BURLINGTON DEVELOPMENT REVIEW BOARD

AGENDA

MEMORANDUM

RE: ZP-23-27; 655 Spear Street

C-3.0

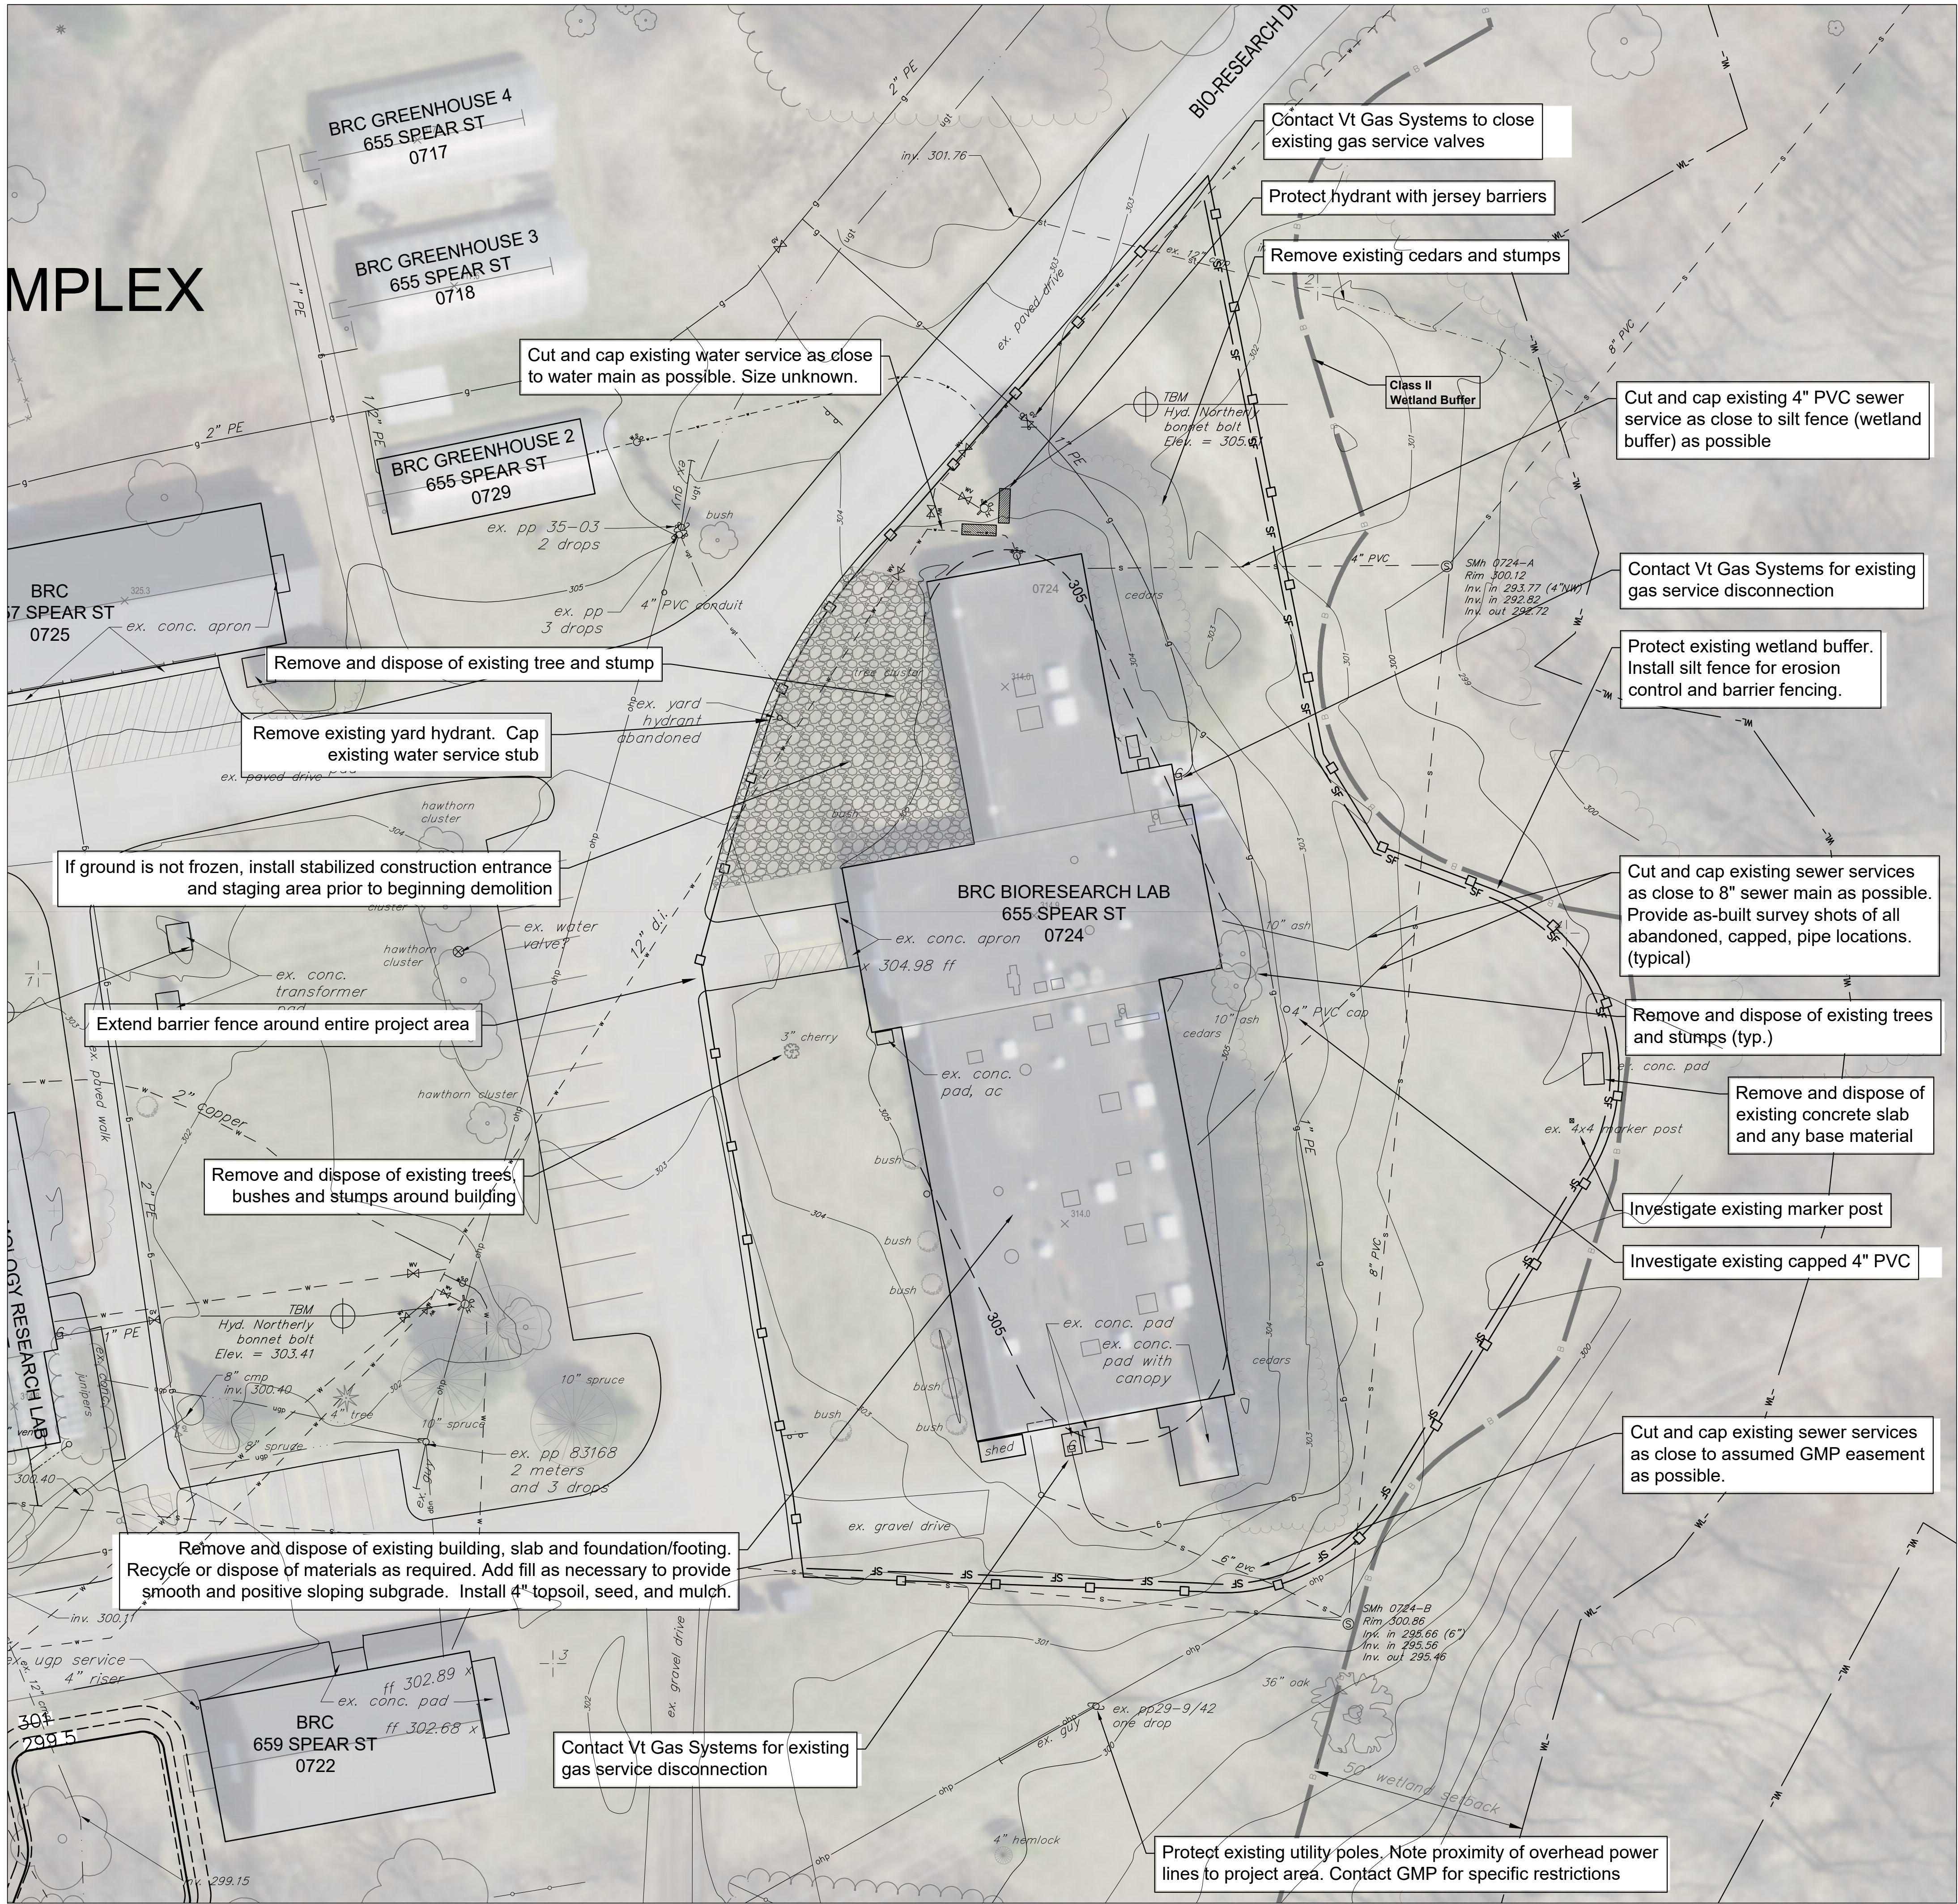
The demolition site is close to a wetlands buffer. The plan includes protection of the identified wetland buffer, with installation of silt fence for erosion control and barrier fencing. See Plan C-3.0. **Affirmative finding.**

The plans include installation of Silt fence and barrier fencing to protect the adjacent wetland buffer. An EPSC plan will be required as more than 400 sf will be disturbed as part of this project. **Affirmative finding as conditioned.**

Plan C.3.0 is entitled *Bioresearch Complex Parking Improvements*; however this application is focused on building and tree removal only. If any changes are proposed to the complex parking arrangement, the applicant shall more specifically define. Parking changes shall be incorporated into the Joint Institutional Parking Management Plan. **Affirmative finding as conditioned.**

2. An Erosion Prevention and Sediment Control plan shall be submitted and is subject to review and approval by the Stormwater Engineer **prior to release of the zoning permit**.

4. If any changes are proposed to the complex parking arrangement, the applicant shall more specifically define. Parking shall be updated within the Joint Institutional Parking Management Plan, as appropriate.
